Date: **May 1, 2000**

Model: **BKM-120D**

Subject: **ABNORMAL RELAY NOISE IN LOW TEMPERATURE ENVIRONMENT**

Figure 2

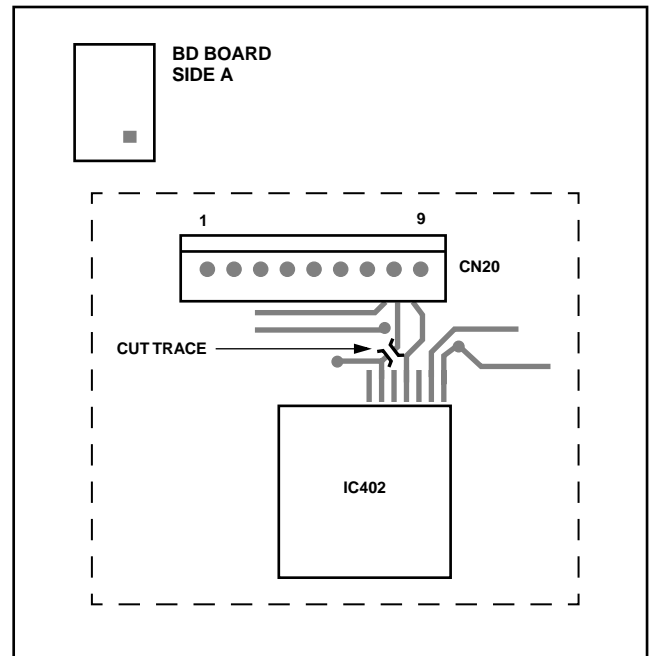
Side A (See Figure 2.)

4. Cut trace leading from IC402 pin 6.

Figure 1

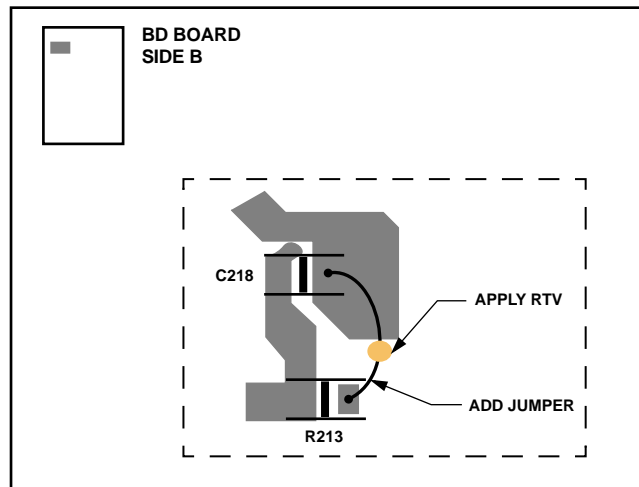
BD Board, Side B (See Figure 1.)

1. Remove the rear panel, and then the top and bottom shield plates.
2. Solder a jumper (UL1007, AWG26, 20mm) between C218 and R213.
3. Apply RTV as indicated.
